## ***Interactive comment on “Decomposition analysis of water footprint changes in a water-limited river basin: a case study of the Haihe River Basin, China” by Y. Zhi et al.***

**Y. Zhi et al.**

Received and published: 18 March 2014

**Fig. 1.** Location of study area (adapted from website of Haihe River Water Conservancy Commission <http://www.hwcc.gov.cn/pub/hwcc/static/szygb/gongbao2011/>)

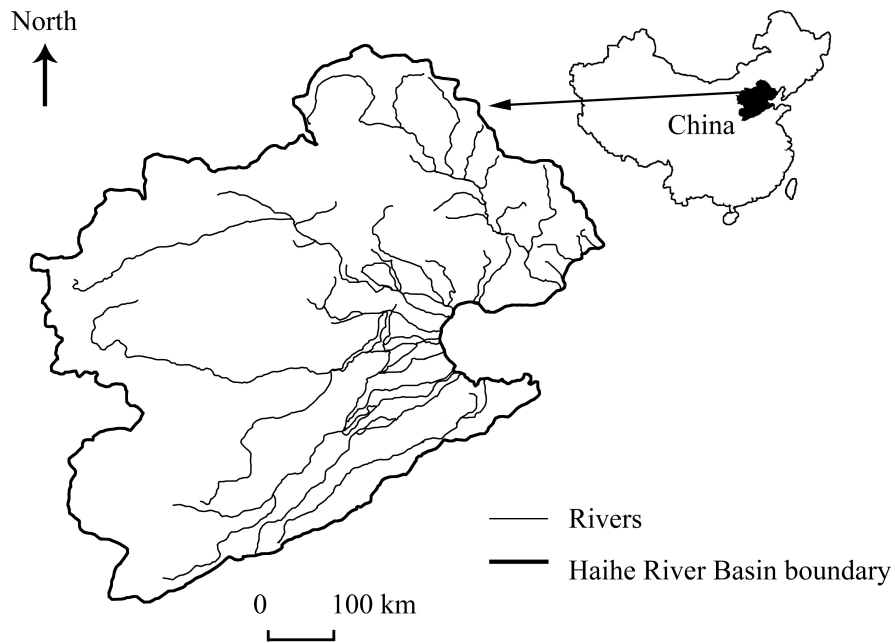
4 The title of 2.1 should be changed as Study area, and a location map should be supplemented in this part; Response: Following this comment, we have changed the title of 2.1 to “Study area” (see page 4, line 21). We have also added the location map as follows, which was adapted from website of Haihe River Water Conservancy.

**Fig. 2.** Figure 2a. WFs in the HRB in 2002

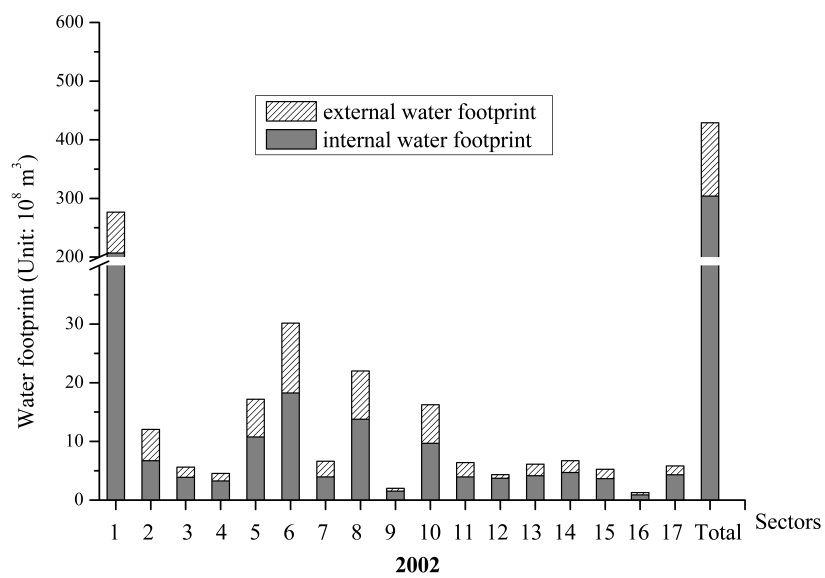
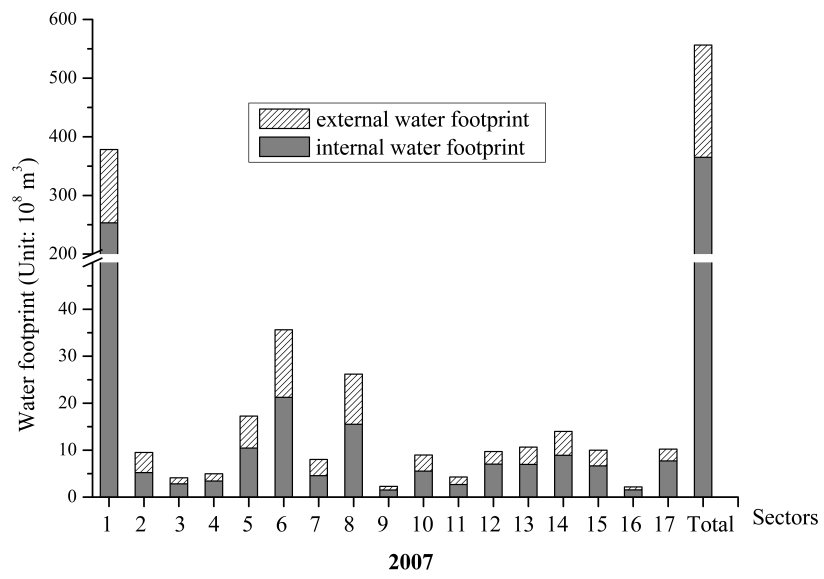
9 The name of X-axis and Y-axis in Fig.1 should be marked. Response: The names of X-axis and Y-axis in Fig.1 (Fig. 2 in the revised version) were added. X-axis meant the number of sectors, and Y-axis meant their water footprints ( $10^8 m^3$ ).
